FENDER MUSICAL INSTRUMENTS
1130 Columbia Street
Brea, California 92621

TECHNICAL SERVICE BULLETIN
NOVEMBER 18, 1986
REVISED 4/15/87
PAGE 1 OF 2

FIELD CHANGE NOTICE 6-003

FIELD CHANGE NOTICE 6-005

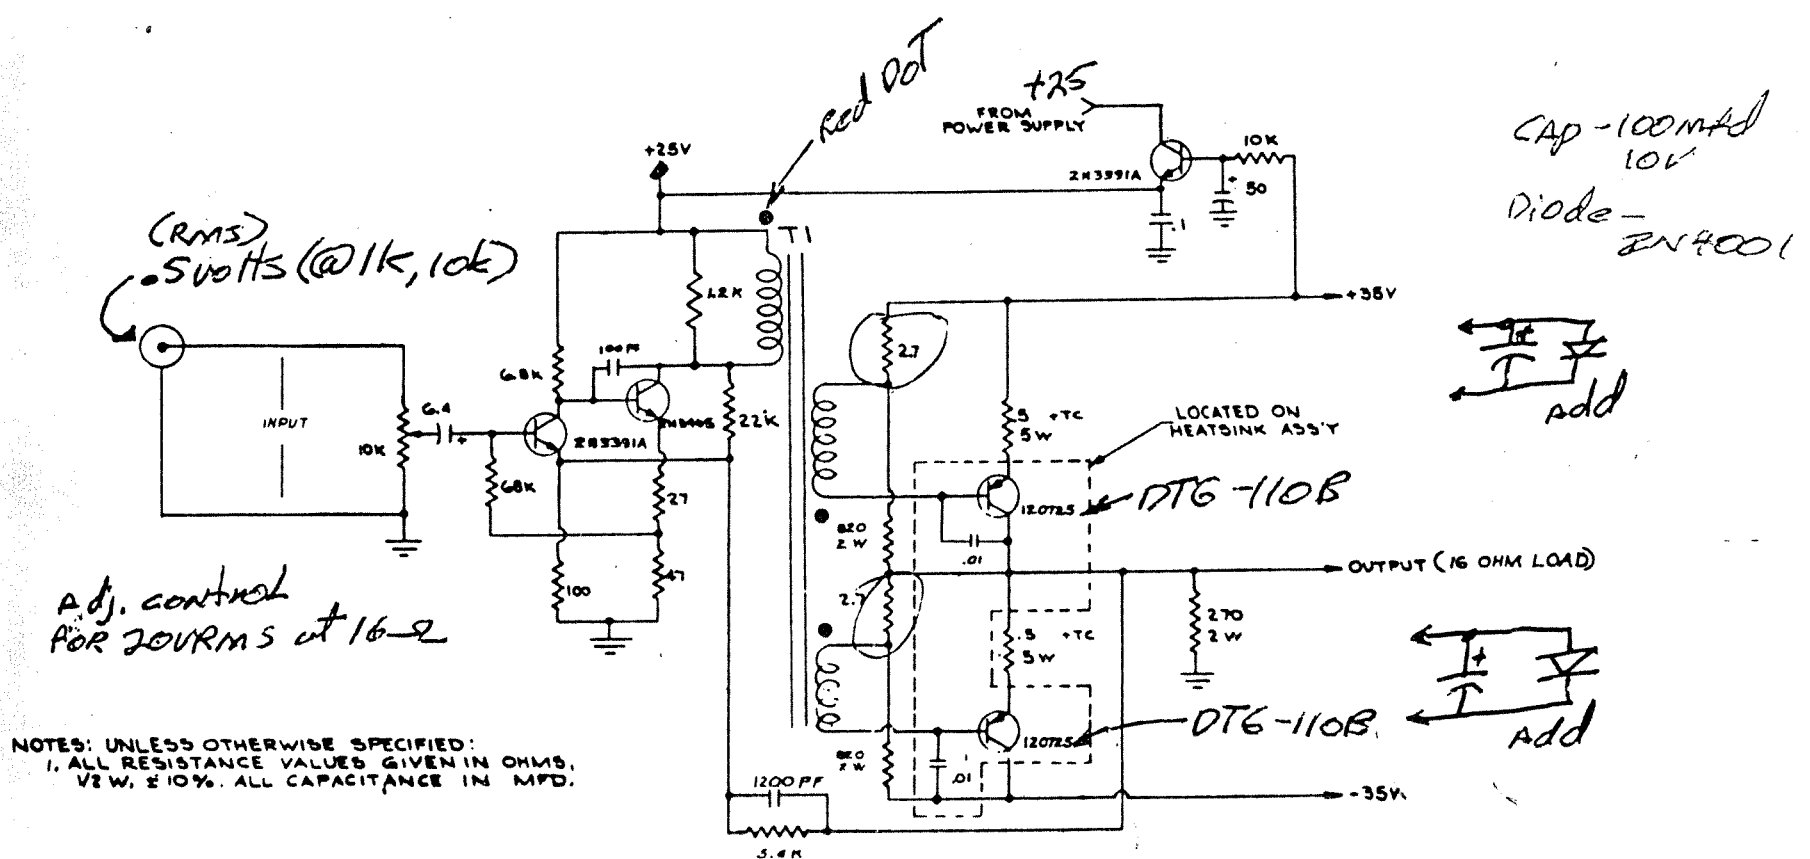
On the preamp board, cut traces to isolate pin 1 of the XLR connector on all input channels except channel 1. Hardwire each XLR pin 1 connection individually to the pin 1 connection on channel 1. **DO NOT DAISY CHAIN THESE CONNECTIONS!** Separate wires must spread out from channel 1, pin 1 in star fashion to pin 1 of each channel but each wire must be kept as short as possible.

Install a 100pf capacitor between pin 1 and pin 2 of each XLR connector. In addition, install a 100pf capacitor between pin 1 and pin 3 of each XLR connector.

SCHEMATIC, REV. A
POWER AMPLIFIER

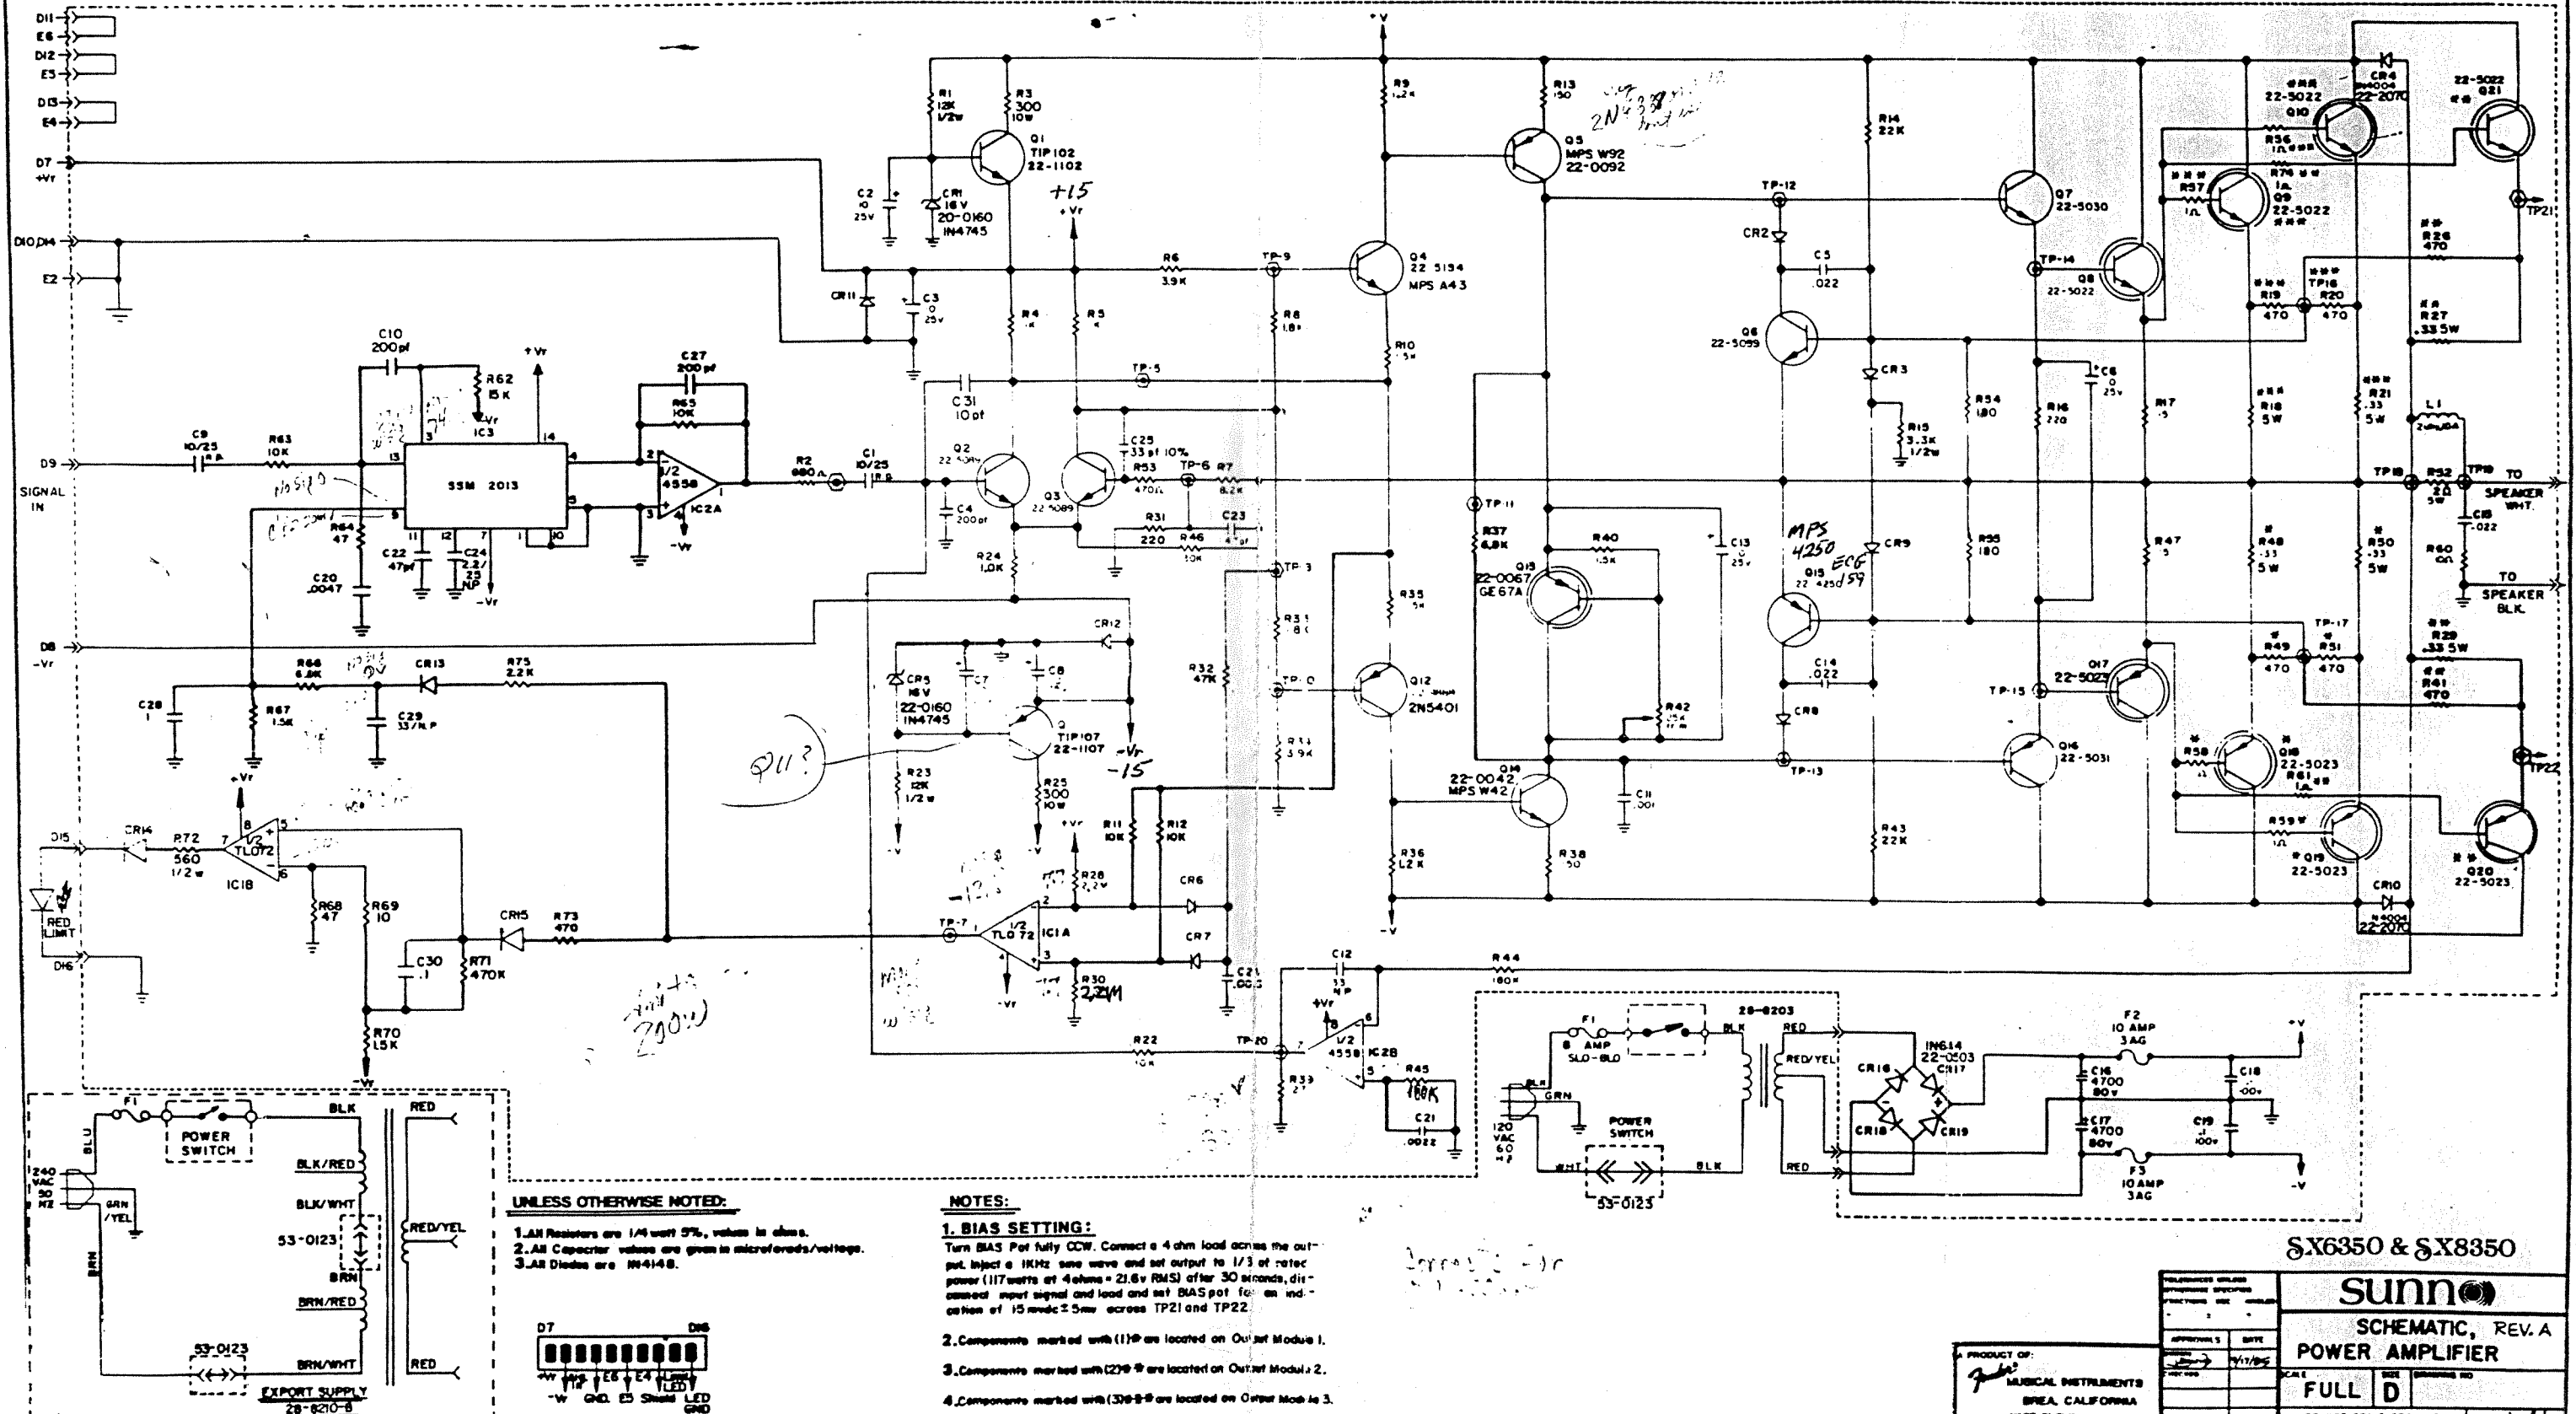
SUNN part number 9909971-510 SX6350 and 9909971-520 SX8350 powered mixers, early production.

To provide better thermal tracking thereby increasing stability and reliability.

Prepare the GE67A transistor for installation by following these two steps: (an RCA SK9143 is an acceptable substitute for GE67A).

1. Increase the mounting hole in its heatsink from 0.140" to 0.156" using a 5/32" drill.
2. Using 4" lengths of 24AWG wire, strip and tin 3/16" from each end. Solder one end of the red wire to the collector, one end of the black wire to the emitter and one end of the green wire to the base. Slide sleeving over the solder joints.
